Comments #52/53/54 on US

Wavelength of Bidirectional 20/40km

Optical PHY for 50GbE

IEEE P802.3cp Task Force, Geneva, January 2020

Impacted to Yield of Upper Bound Wavelength of US at 1296nm

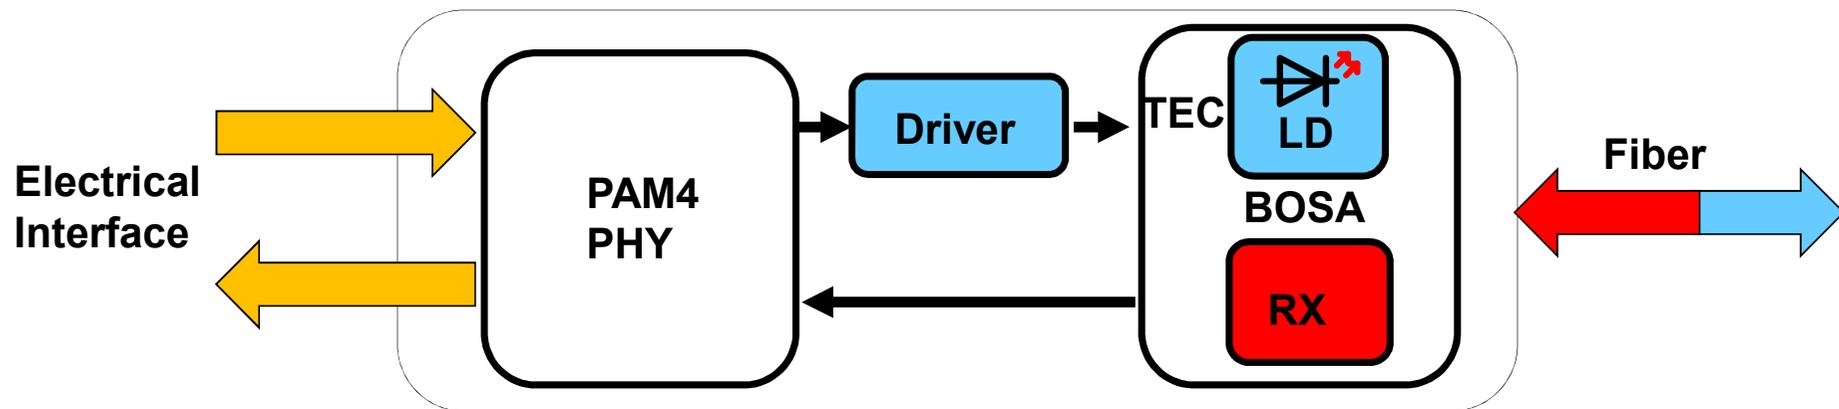
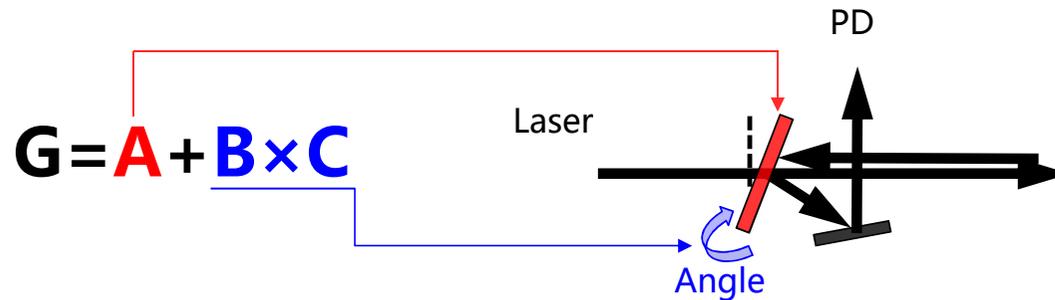
- For current production which would satisfy the IEEE standards, one of the wavelengths would be 1294.53-1296.59nm, which would be perfectly satisfied and could be reused for 50GbE BiDi 20/40km application. If the upper bound wavelength range tightens to 1296nm, the yield would be degraded ~20% without temperature control or ~10% with temperature control, based on module vendor's feedback.
 - TEC current should be increased to shift the wavelength range from 1296.59nm to 1296nm.
- Under high temperature working environment, the case would be further worse which would lead to higher power consumption.

Feasibility of Wavelength Gap of Bidirectional PHY (Cont'd)

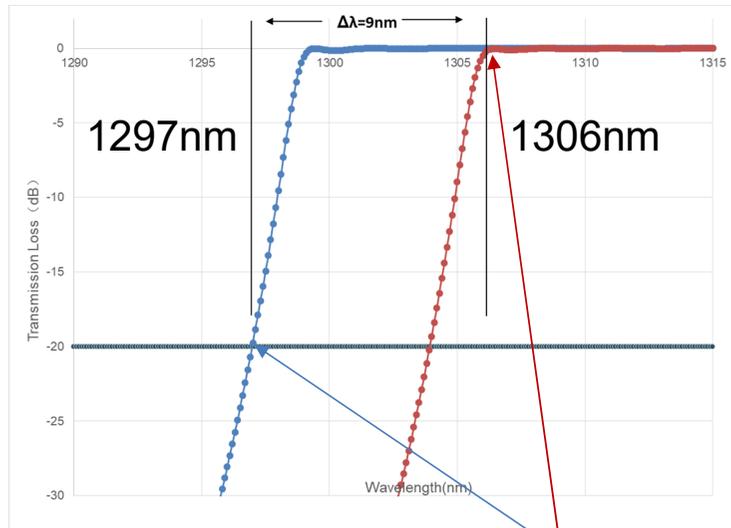
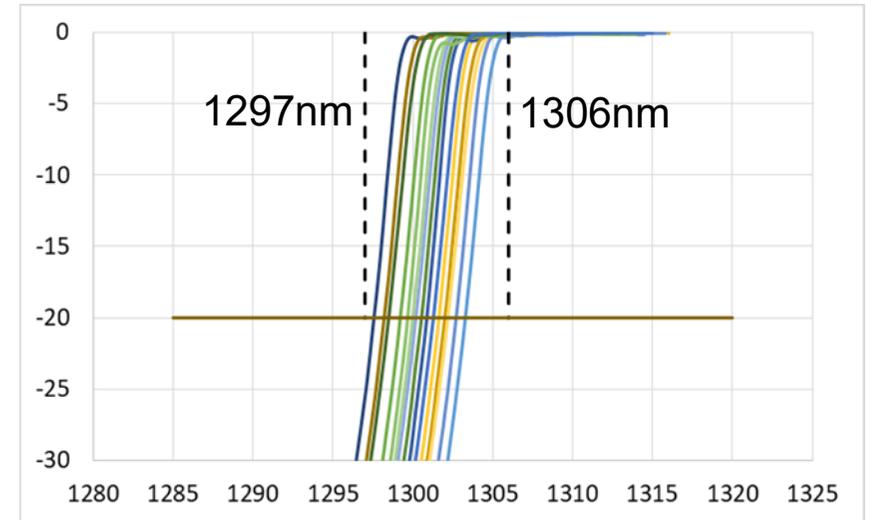
G = Wavelength (max-min)

- From theoretical simulation results, considering the minimum and maximum assemble angle deviations, $\geq 9\text{nm}$ guard band is sufficient;
- Practical results indicate roll-off edges locate between 1297 to 1306nm.
